**DELAWARE VETERANS MEMORIAL CEMETERY
BEAR, DELAWARE
DE-15-22
BID SET DOCUMENTS**

ADDENDUM NO. 1
June 21, 2016

The attached Sketches, dated 6/4/2016, depict the following described revisions made to the plans as part of Addendum 1:

GI002-SK-3

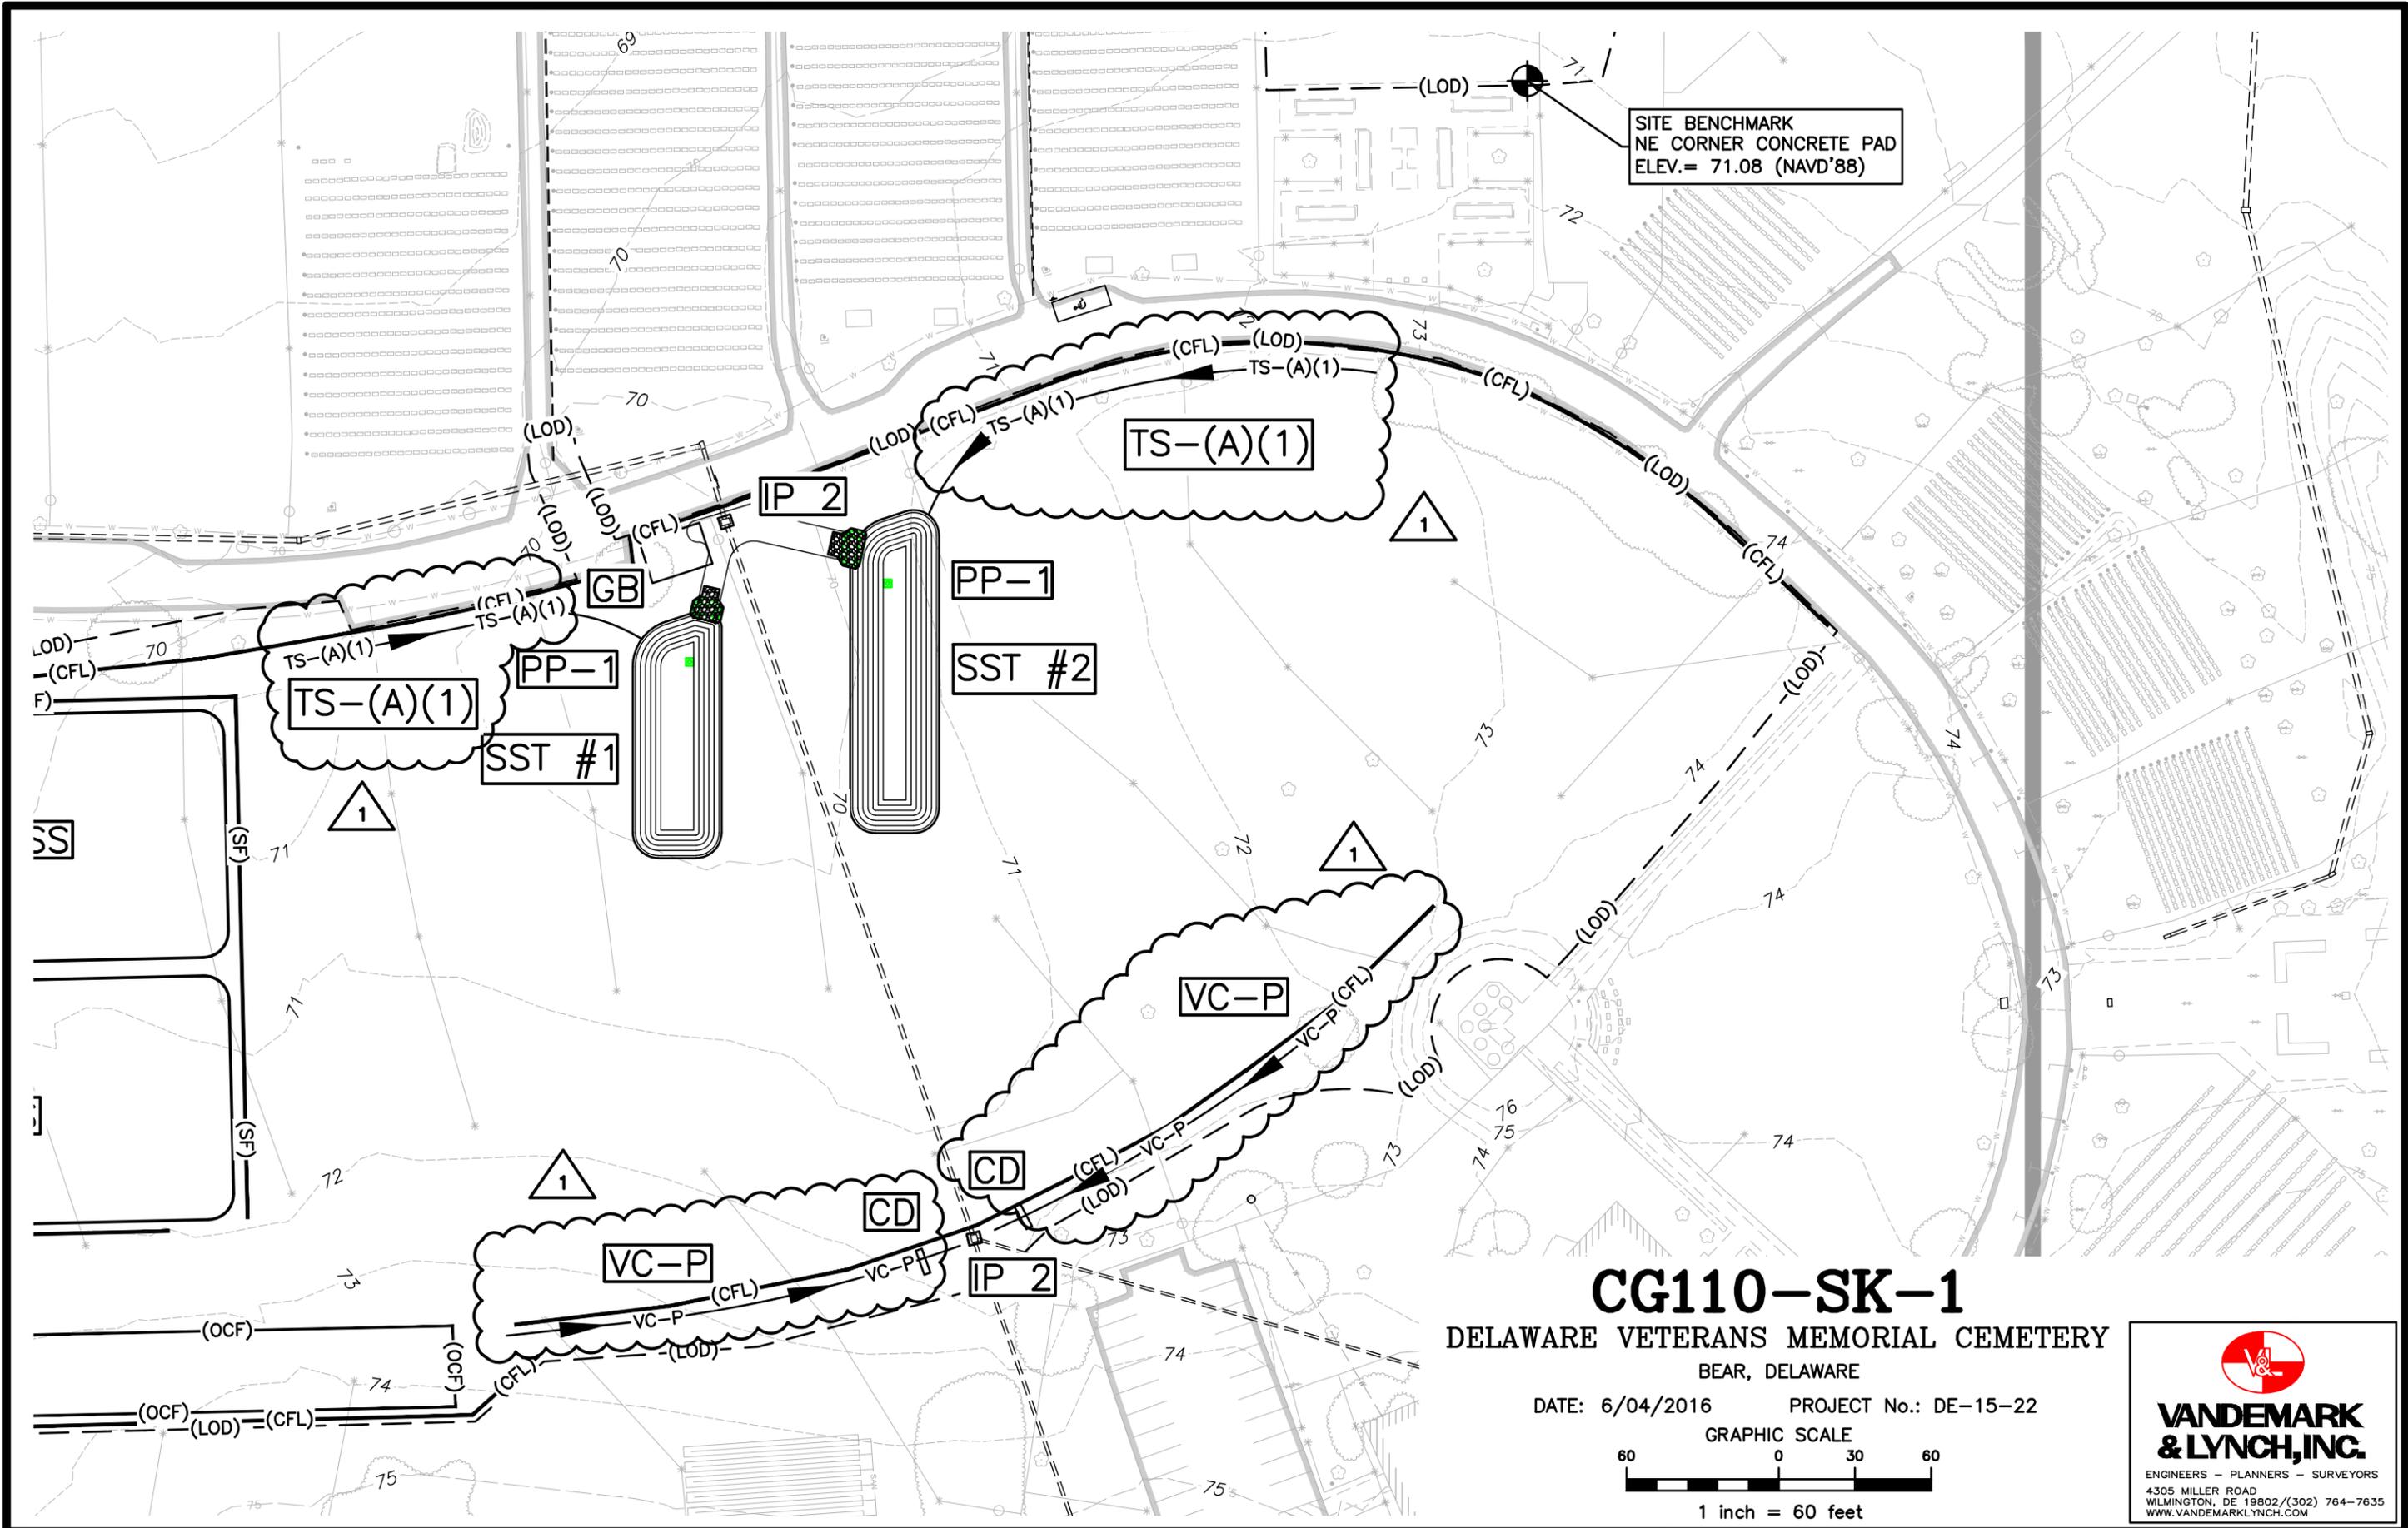
2. GI002-SK-2: Revised Sequence of Construction note 5 to list revised erosion and sediment controls.
3. GI002-SK-3: Revised stabilization matting product recommendation to North American Green S150.

CG111-SK-2
 DELAWARE VETERANS MEMORIAL CEMETERY

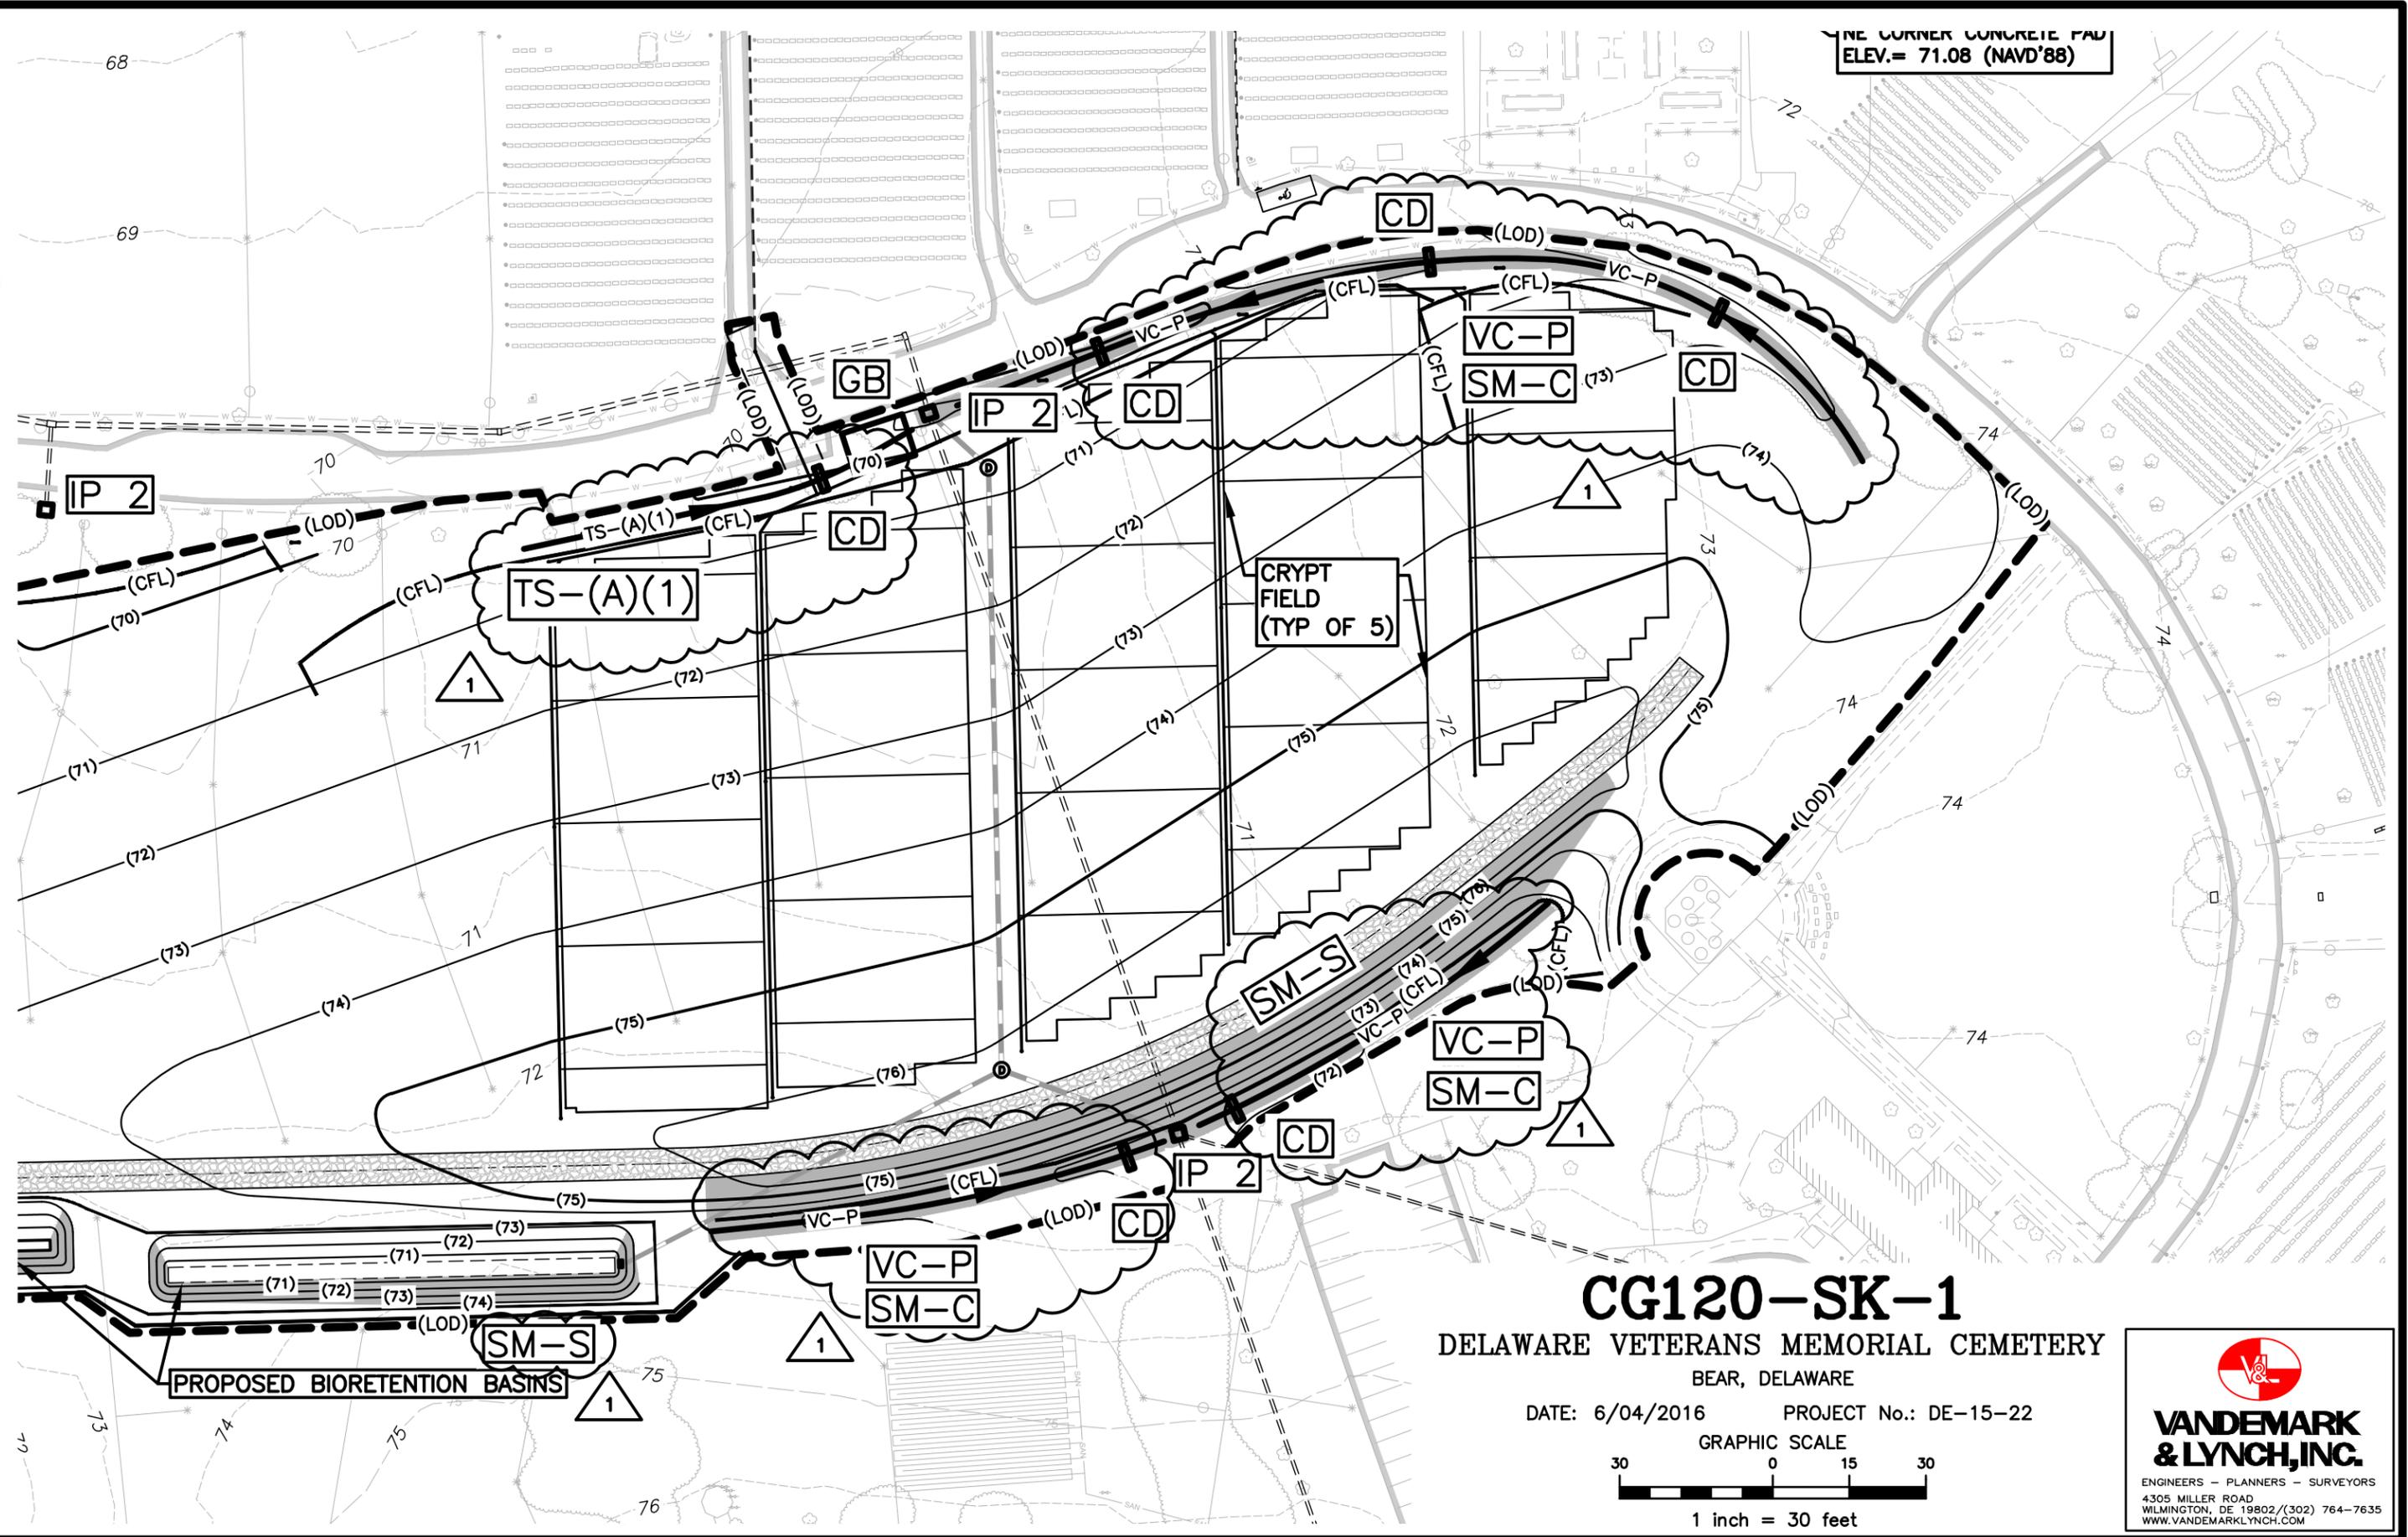
5. CG111-SK-1: Diversion Swale callouts changed to Temporary Swale callouts. Add drainage area labels.
6. CG111-SK-2: Diversion Swale callouts changed to Vegetated Channel - Parabolic callouts. Add drainage area labels. Stone Check Dams callout changed to Compost Filter Log Check Dams callout.

CG122-SK-1

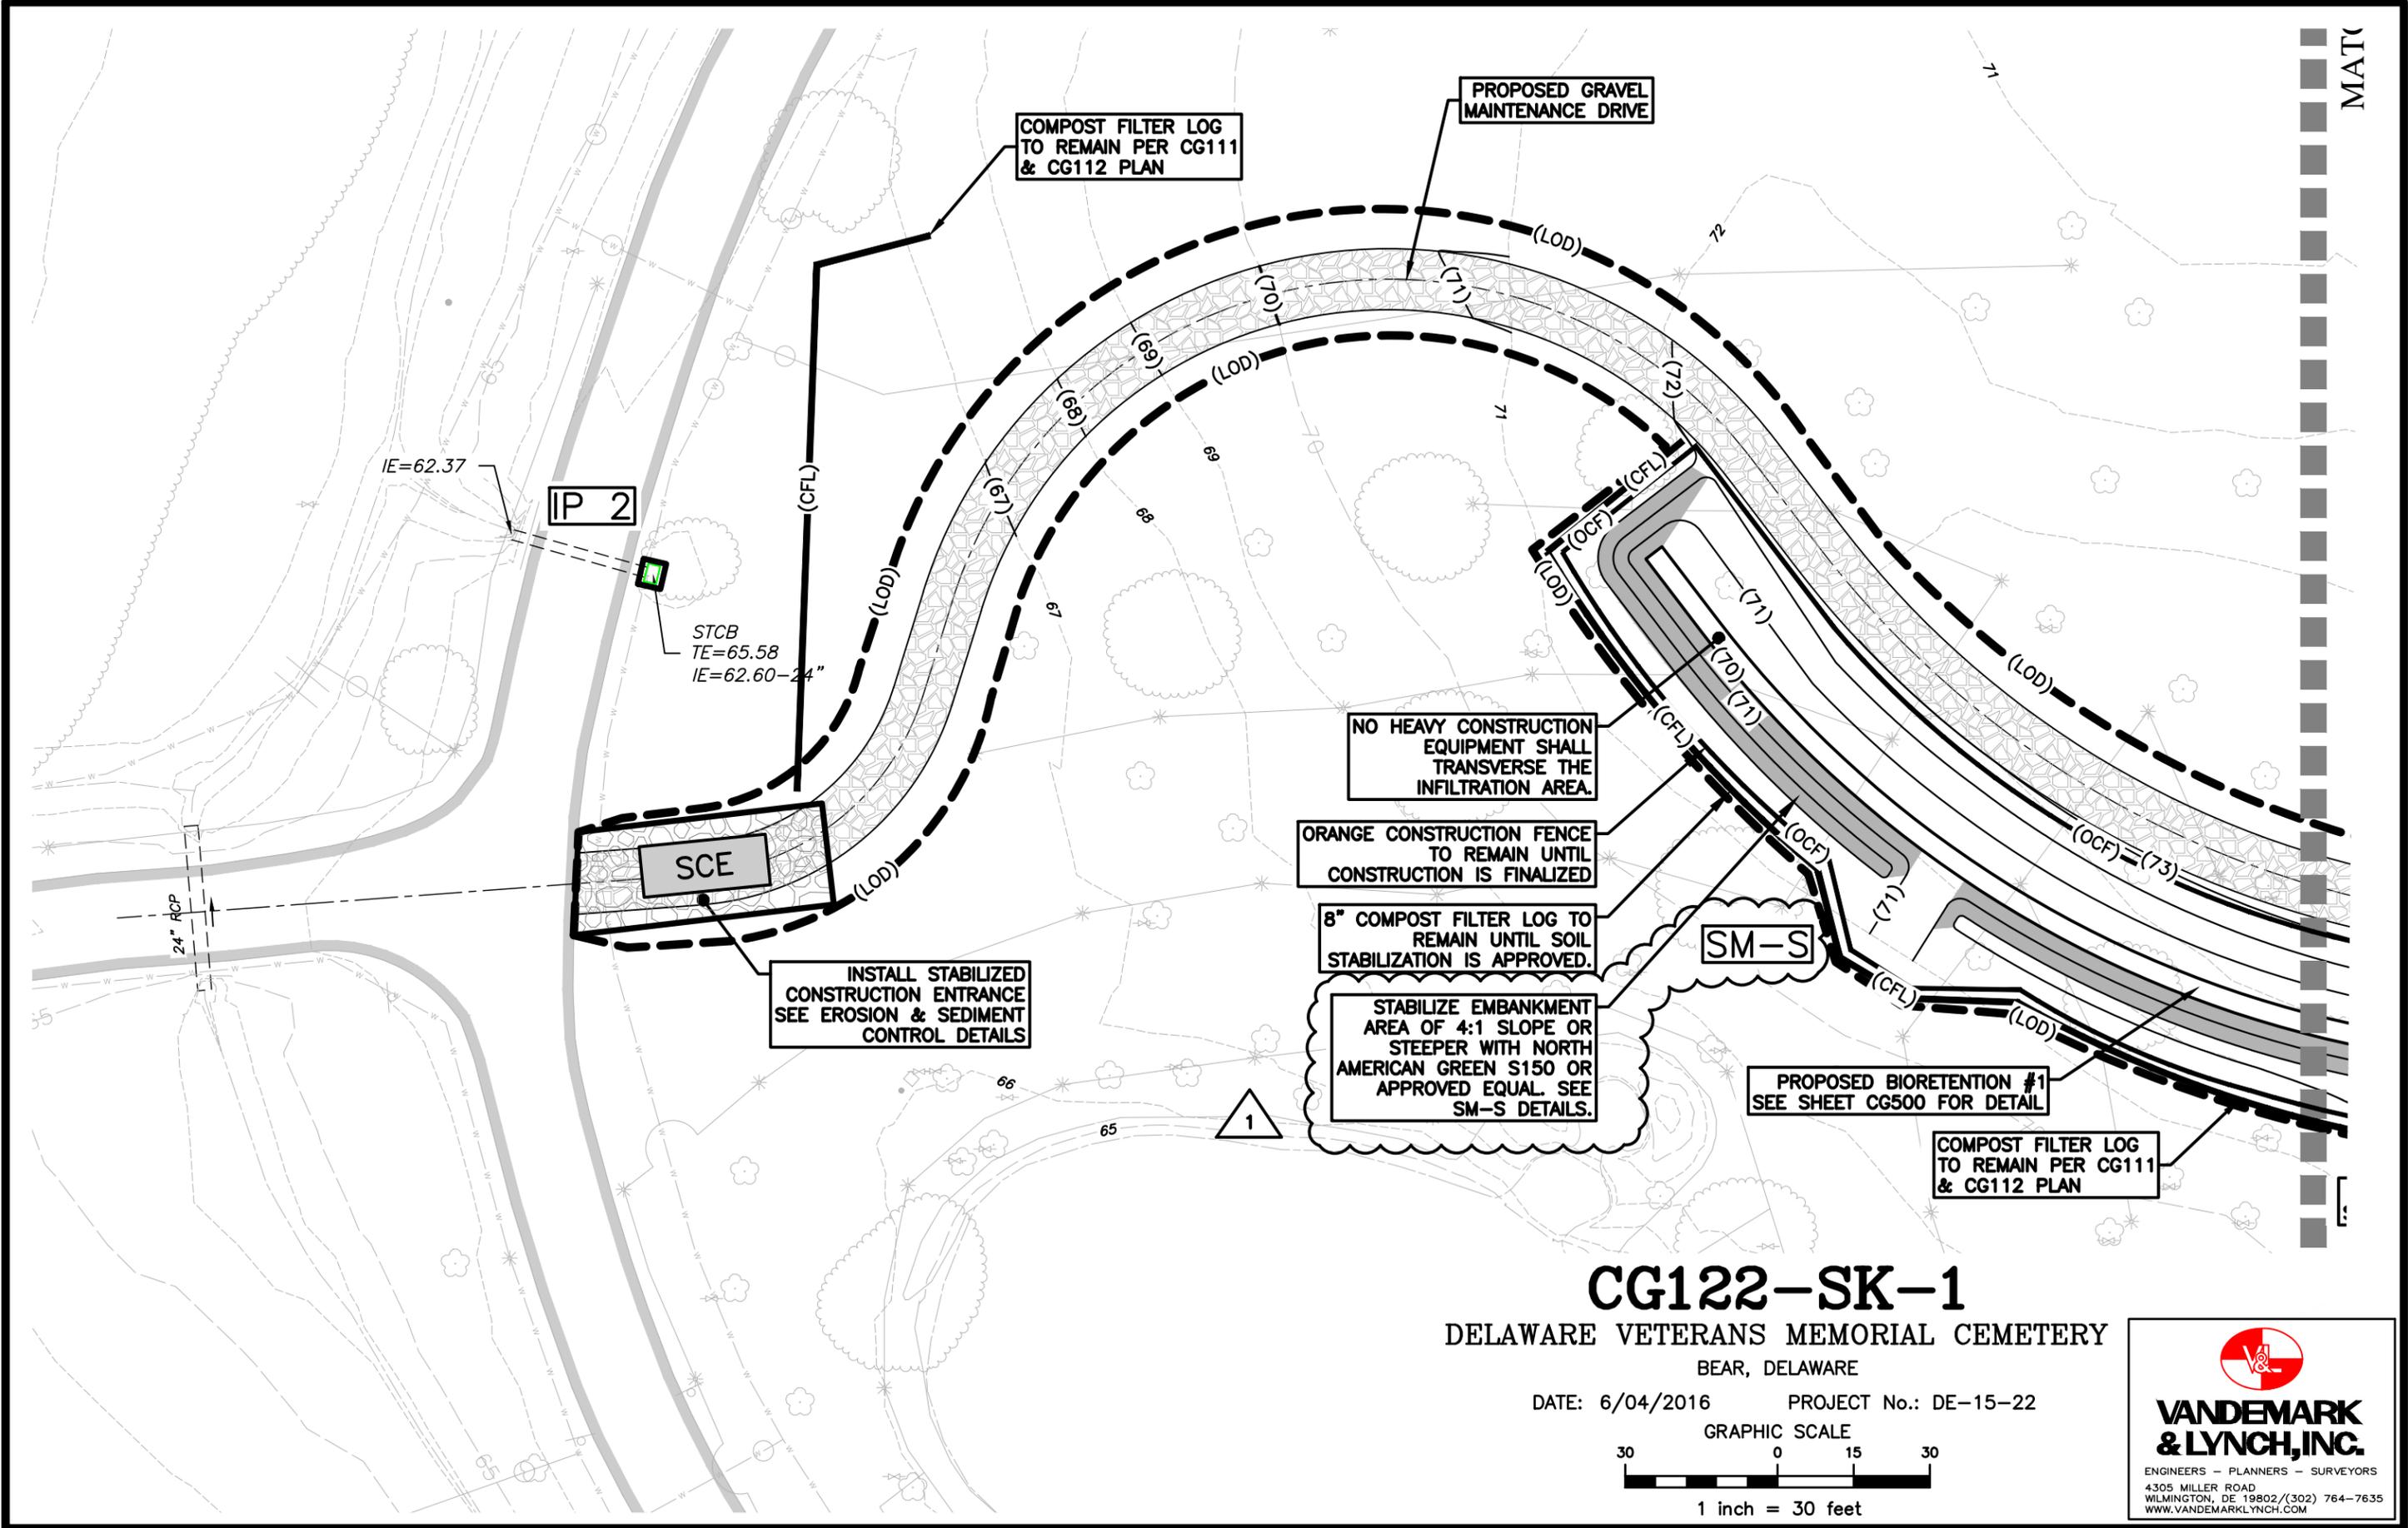
12. CG121-SK-4: Add Stabilization Matting –Slope callouts.
13. CG122-SK-1: Add Stabilization Matting –Slope callouts.
14. CG141-SK-1: Revised various underdrain/cleanout inverts, top elevations and lengths.
